Value Engineering Study Report
– Final

I-69 Ohio River Crossing Project
Evansville, IN and Henderson, KY

August 2, 2019

Idea Title	Reconfigure the US 41 interchange to reduce structure requirements
Function	Access Community

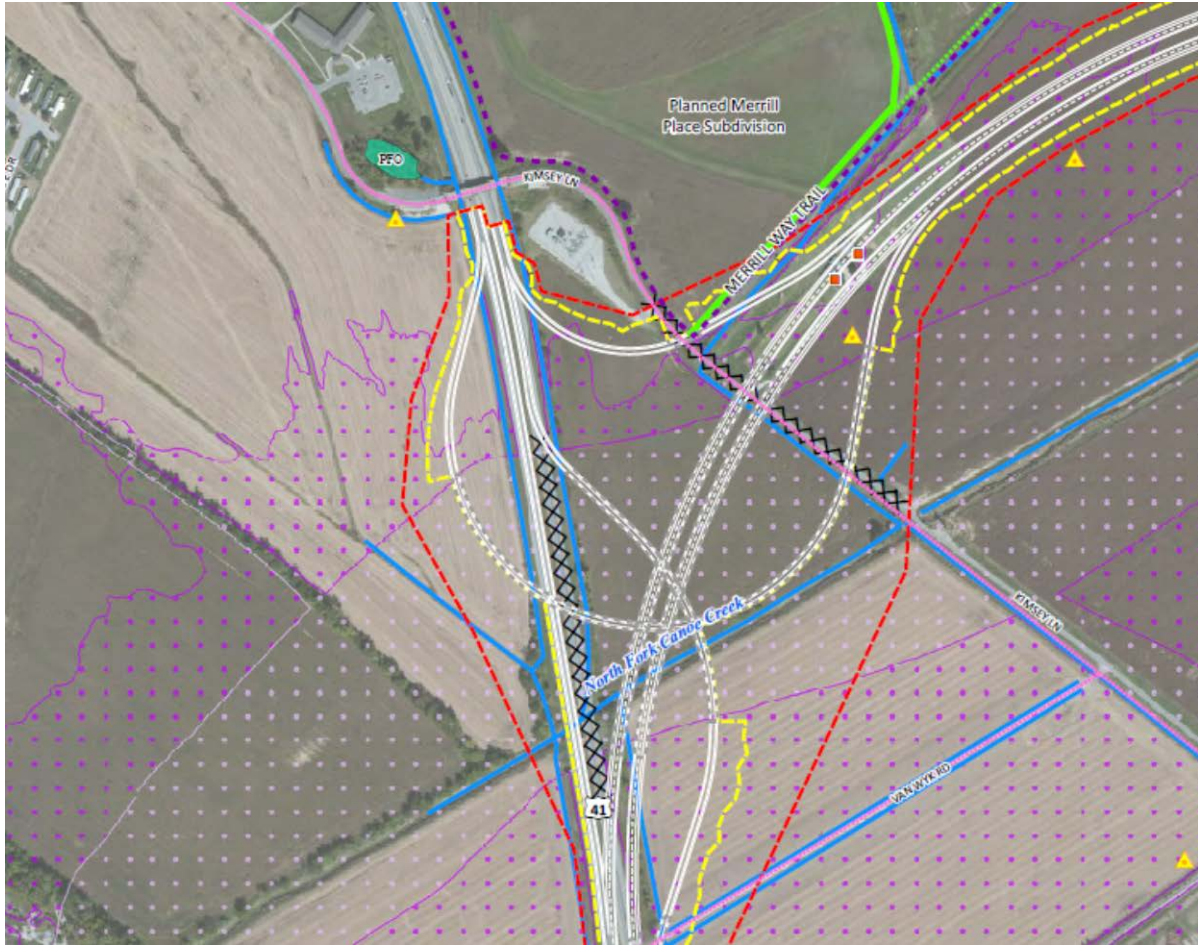
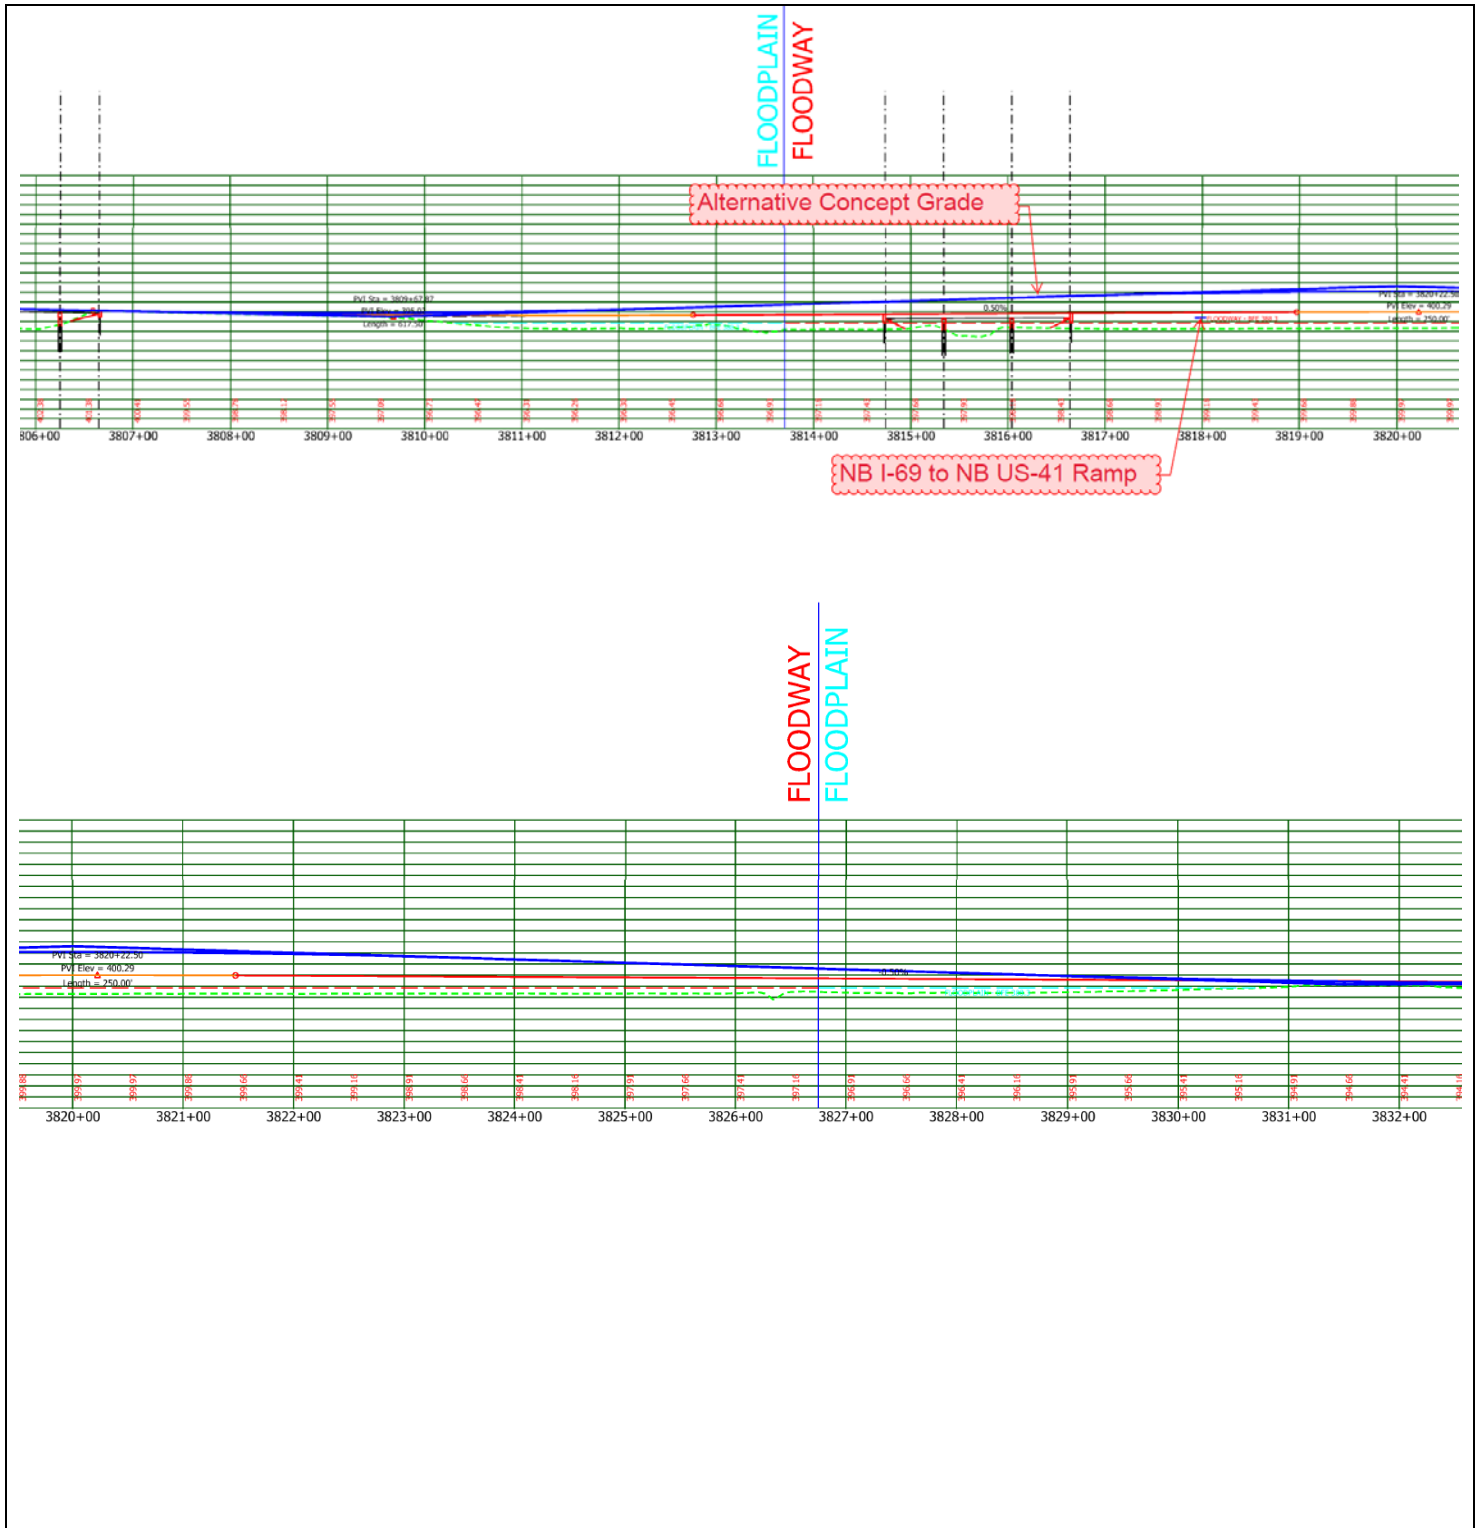
Additionally, a signalized single crossover and a Single-Point Urban Interchange (SPUI) alternative were briefly reviewed for this location, but the project team’s expressed desire to maintain an unimpeded movement for through traffic on US 41 halted further exploration. The single crossover required implementation of a multi-level interchange, where the cost savings would have been negligible.

Maximum grade is 3%. Blue line is Alternative Concept Grade

Idea Title	Reducing the amount of structure on US 41 interchange by a more detailed hydraulic analysis
Function	Access Community

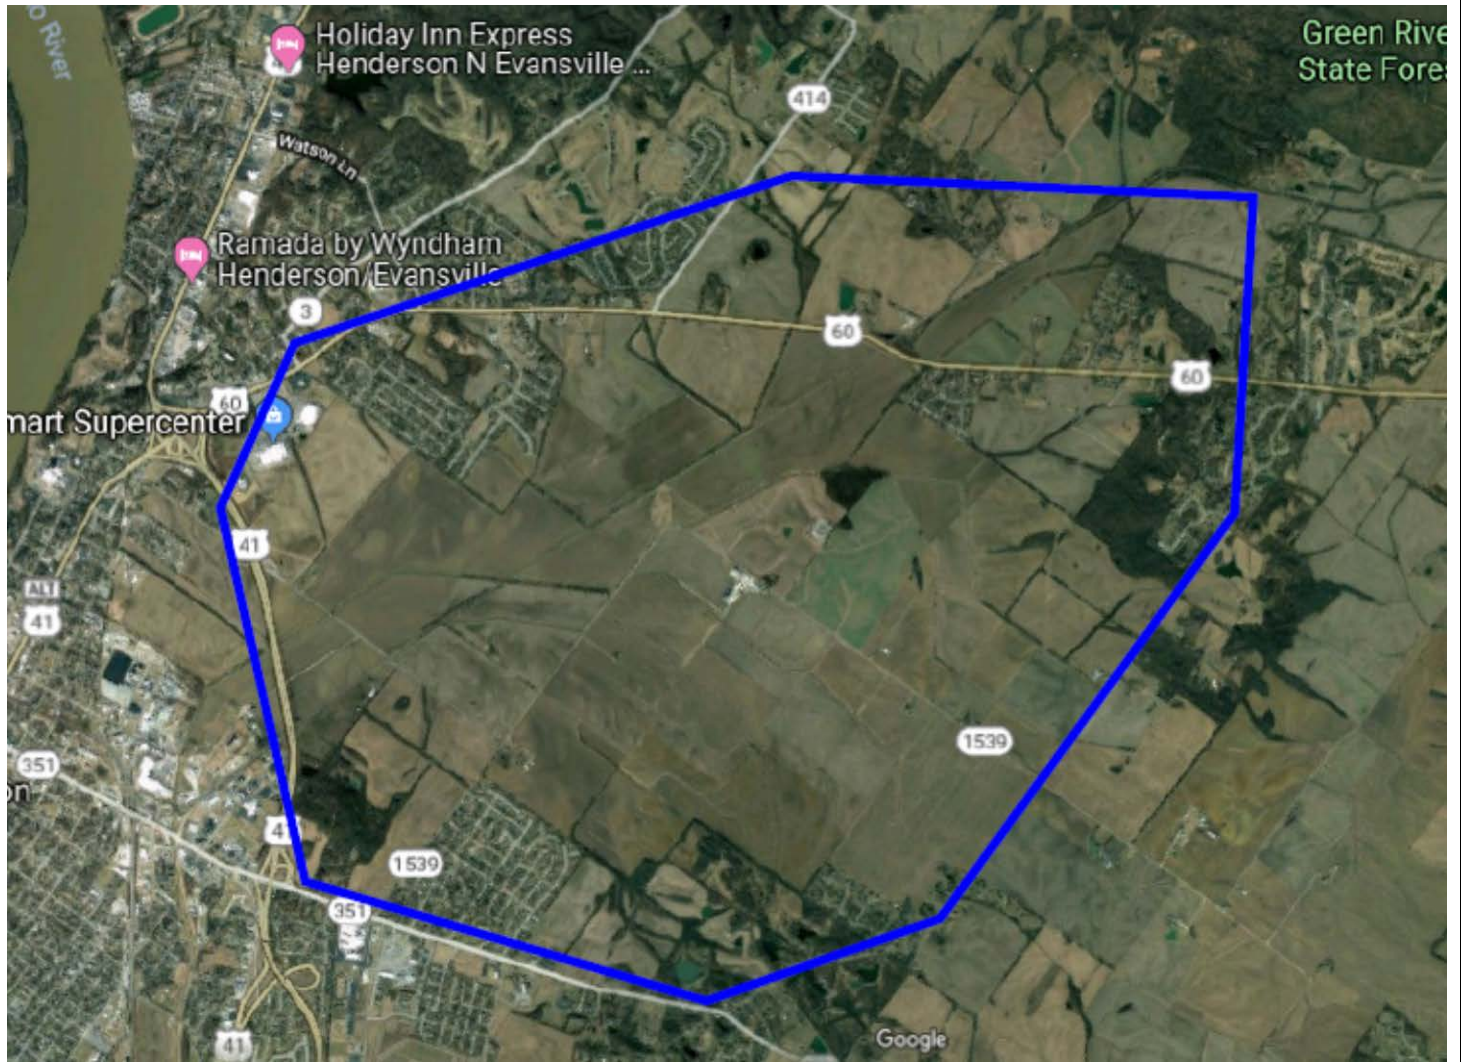
The hydraulics around proposed I-69 / Canoe Creek area offers unique opportunity to reduce the bridge structure within the floodway areas. In Figure 2, this proposal reduces the hydraulic opening to about 250 feet. There are three factors supporting replacing bridge structure with embankment or roadway within the floodway area:

2. Based on a rough measure from Google Map, the Canoe Creek covers a tributary area of about 20 square miles (see Figure 1). Therefore, the amount of water expected to flow out of Canoe Creek at the US 41 interchange is small. The floodway area here behaves more as storage, not waterway. Additional storage capacity can be easily provided to compensate the area occupied by proposed roadway within the floodplain.

3. The Kentucky one-foot back water requirement provides a relatively large allowance in terms of hydraulic impact. Considering the rather small tributary area and the flat and large flood storage area, it will be very unlikely the proposed change will result in high back water.

The estimate provided does not reflect the current bridge layout. Measured from the current bridge layout, the bridge areas of the four structures are: I-69 northbound on ramp 65,025 sf, I-69 NB off ramp: 29,360 sf, I-69 NB: 59,700 sf, I-69 SB 61,200 sf, for a total of 215,285 sf. Figure 2 shows the proposed bridge layout, using a hydraulic opening of 250 feet. The proposed bridge areas are approximately: I-69 north bound on ramp 43,500 sf, I-69 north bound off ramp: 17,600 sf, I-69 north bound: 15,000 sf, I-69 south bound 15,000 sf, for a total of 91,100 sf. The average bridge cost from the estimate is about \$300 per square foot. There would be an estimated saving of \$190 per square foot from bridge to embankment. The total saving of this proposal is estimated at \$23.6M.

Idea Title	In lieu of bridge/fill, use prefabricated culvert (BEBO)
Function	Span Space

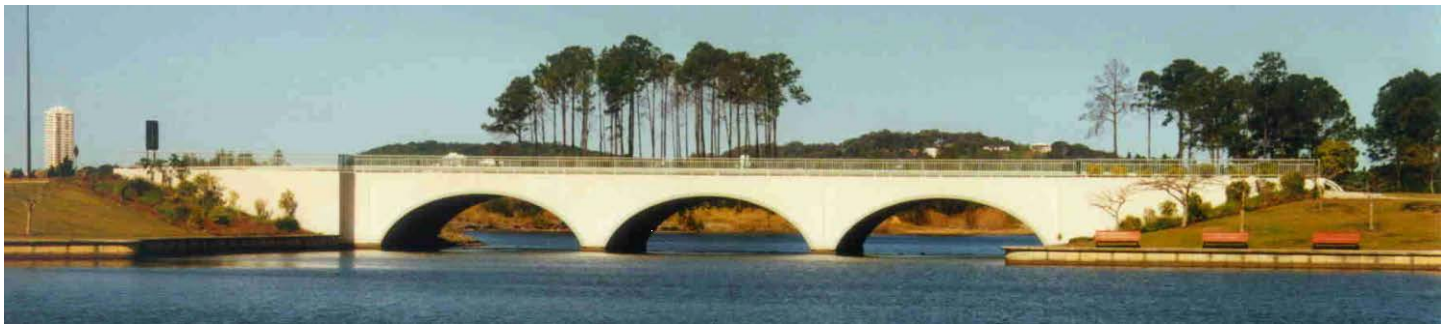
The alternative concept proposes to use buried type structures such as BEBO or multiplate arch type structures and replace the north approach bridges for I-69. This would replace the original fill section north of the river crossing around Station 4150+00 with an equal amount of foundation in the floodplain for BEBO structures.

Hydraulic impact and surge need to be further analyzed because of restricted flow, added friction and freeboard requirements.

This concept could completely replace the north I-69 approach over floodplain which is about 494,000 square feet of aerial structures. The original estimate assumed \$135 per square-foot for this area and BEBO structure

Idea Title	Use trench section in lieu of bridges in the floodplain
Function	Span Space

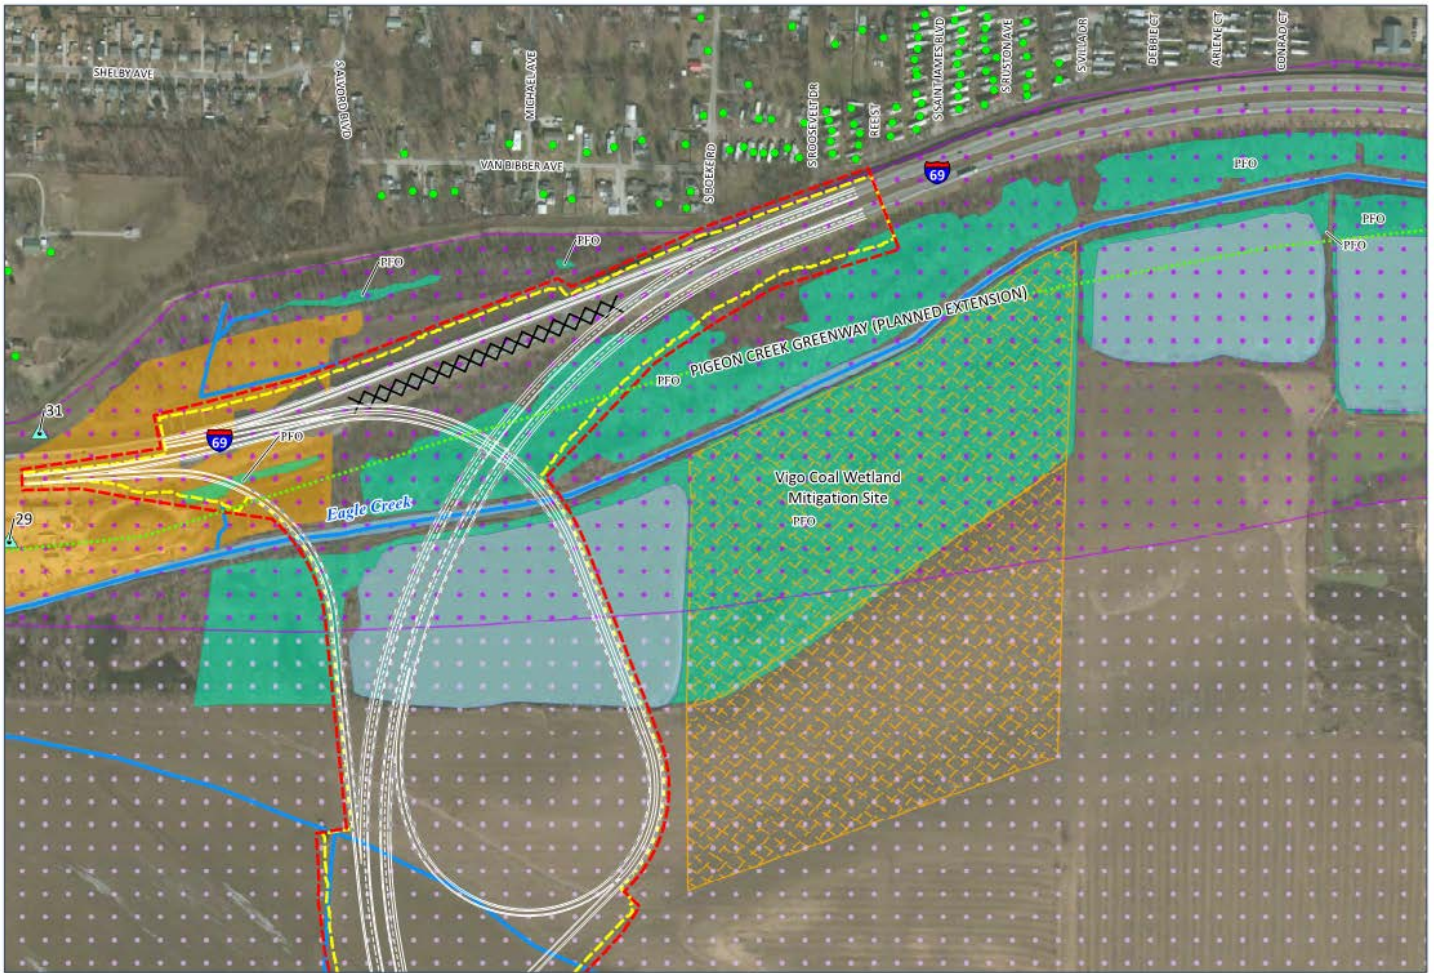
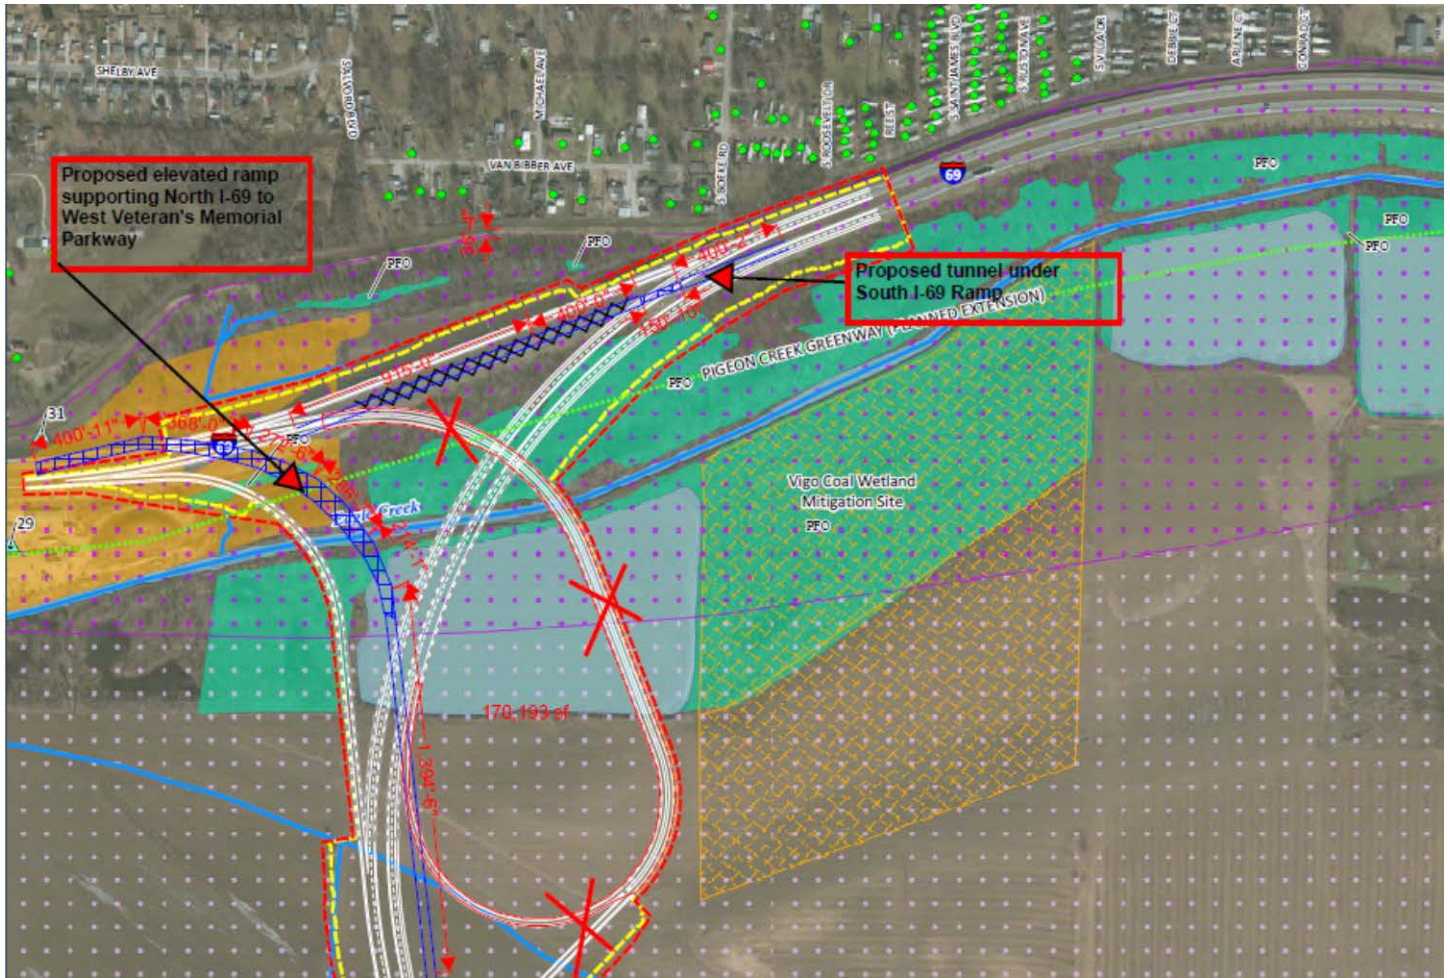
ALTERNATIVE CONCEPT:
Remove the elevated ramp connecting Veterans Memorial Parkway to proposed I-69 southbound and replace with depressed / tunnel segments and elevated ramp.

ALTERNATIVE CONCEPT DISCUSSION / JUSTIFICATION:
Existing Veterans Memorial Parkway:
Depress the east bound lanes as the Parkway ties into I-69 North. The deepest point will result in a 150 LF tunnel section of the Parkway. This tunnel section allows the proposed I-69 South ramp to cross the Parkway at grade. The first modification allows for removal of the proposed elevated looping ramp system providing connectivity of the Parkway to I-69.

The second modification involves constructing a 3,000 LF elevated ramp connecting proposed North I-69 to West Veterans Memorial Parkway.

The combination of these two modifications allows for the removal of approximately 180,000 SF of bridge.

- Dewatering and management of groundwater during construction
- Support of excavation
- Flood management of the finished tunnels
- Safety and monitoring systems for the finished tunnel
- Access to the work zone during construction
- Interstate regulations related to construction below flood level

Idea Title	In lieu of pier support islands, build roadway embankment on the north to shorten bridge
Function	Miscellaneous

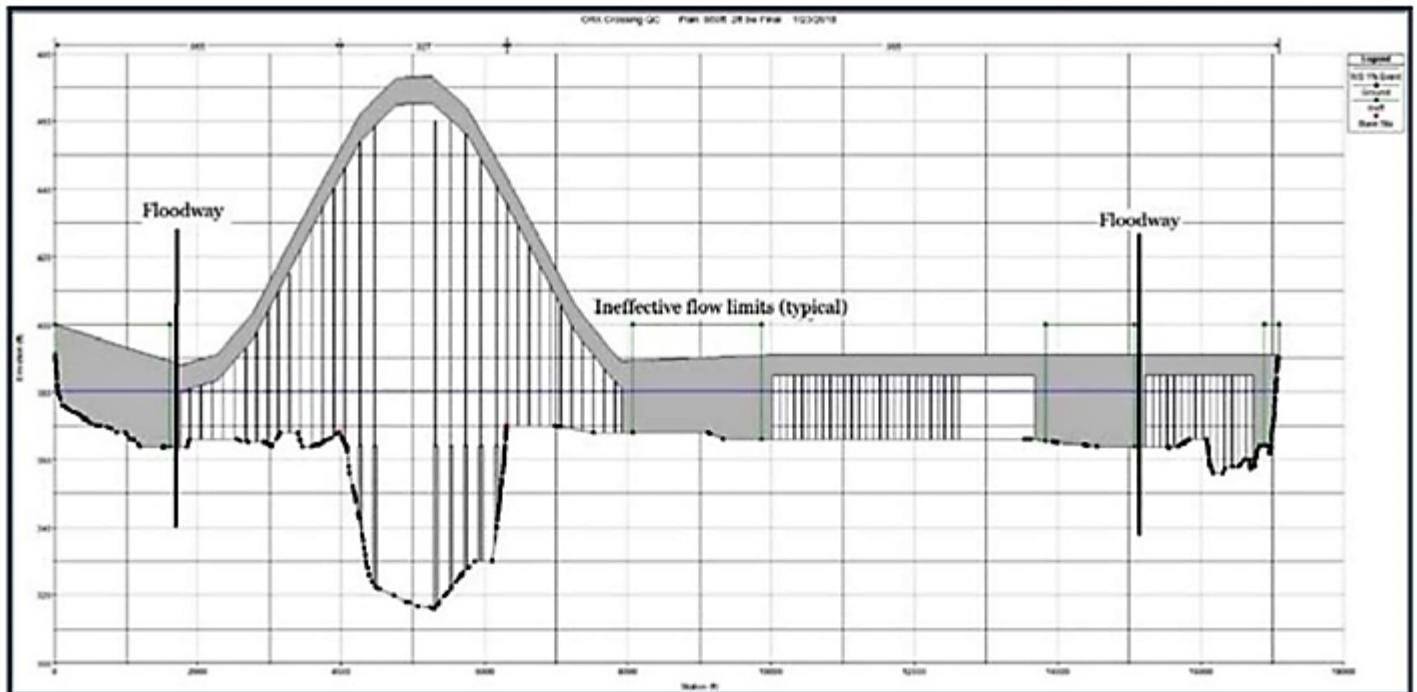
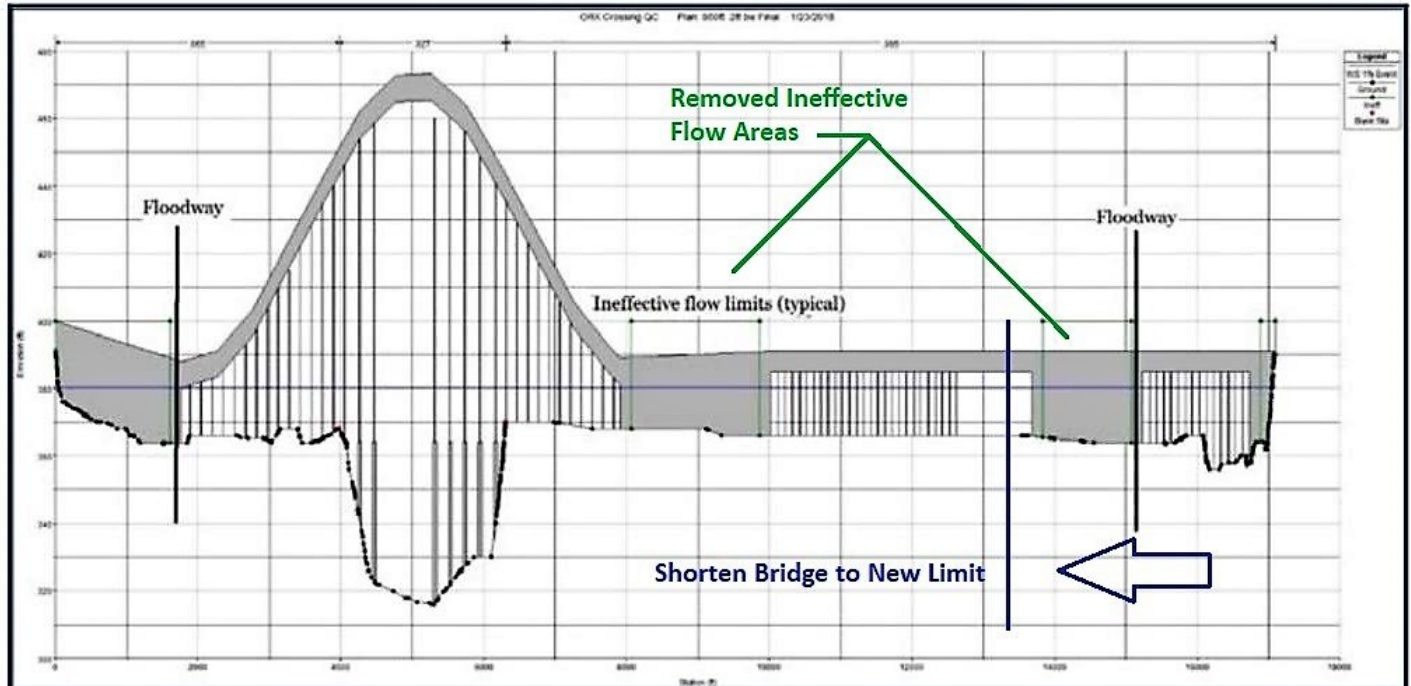
Instead of constructing these islands which remove flow area from the river cross section, remove that flow area from the north end and shorten the structure.

Permits from the U.S. Army Corps of Engineers would need to be modified if already obtained. If a Letter of Map Revision (LOMR) has been completed, it would need to be re-done.
